ATTACHMENT B

Kielty Arborist Services LLC

Revised March 6th, 2023

Site: 1219 Portland Avenue, Los Altos CA

Plan Review: *(Site plan A1.1 dated 1/3/22)*

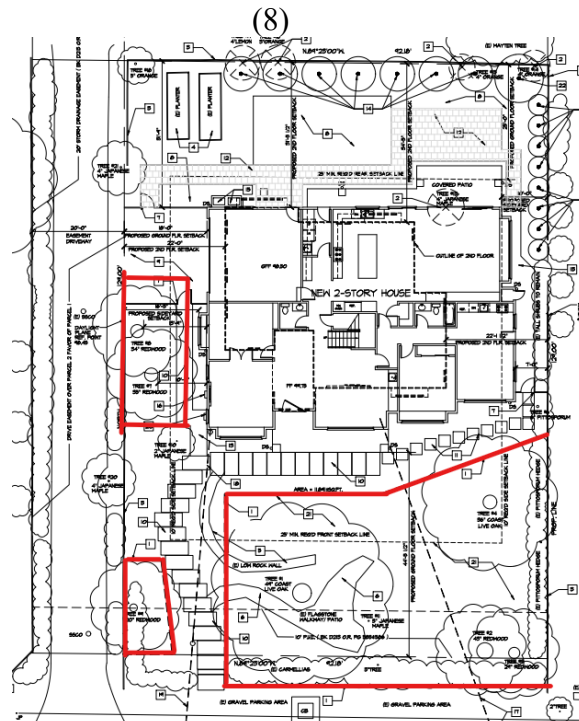
New concrete pathways and step stones are proposed near the outer edge driplines of oak trees #1 and #4. The finished grade of the hardscapes are recommended to be slightly above grade so that any roots encountered within the base rock sections can be retained by packing base rock around roots. Excavation for the hardscapes is recommended to be done by hand under the Project Arborist supervision is recommended. Roots measuring smaller than 2" in diameter can be cleanly cut using a hand saw or loppers as needed. Any roots measuring 2" in diameter or larger are recommended to be retained within the base rock. Impacts are expected to be minor to nonexistent from the proposed hardscapes. No mitigation measures are needed at this time. Mitigation measures will be recommended as seen fit during the Project Arborist visit to the site to witness the excavation for the hardscapes.

Redwood trees #7 maintains a 10'-8" clearance between the tree and the proposed foundation while redwood tree #8 maintains a 13'-9" clearance. Redwood trees have a good tolerance to construction impacts as seen in the Matheny & Clark tree tolerance chart. The foundation at within 25 feet from the Redwood trees is recommended to be excavated by hand under the Project Arborist supervision. The foundation of the home is recommended to be a pier and grade beam type of foundation to give the opportunity to bridge over tree roots were needed. All encountered roots measuring 1.5" in diameter or larger are recommended to be exposed and remain as damage free as possible for the Project Arborist to view and document. Where needed roots should be cleanly cut using a hand saw or loppers while under the Project Arborist supervision. Impacts are expected to be minor. The Redwood trees are recommended to be irrigated weekly using 50 gallons of water during the dry season. The Redwood trees are also recommended to be deep water fertilized before the start of construction. The irrigation and fertilizing will act as mitigation for the minor impacts. The proposed pathway near the trees is recommended to be built by hand on top of grade. No roots for any reason shall be cut for the pathway construction. During the pathway construction, the tree protection fencing will need to be reduced.
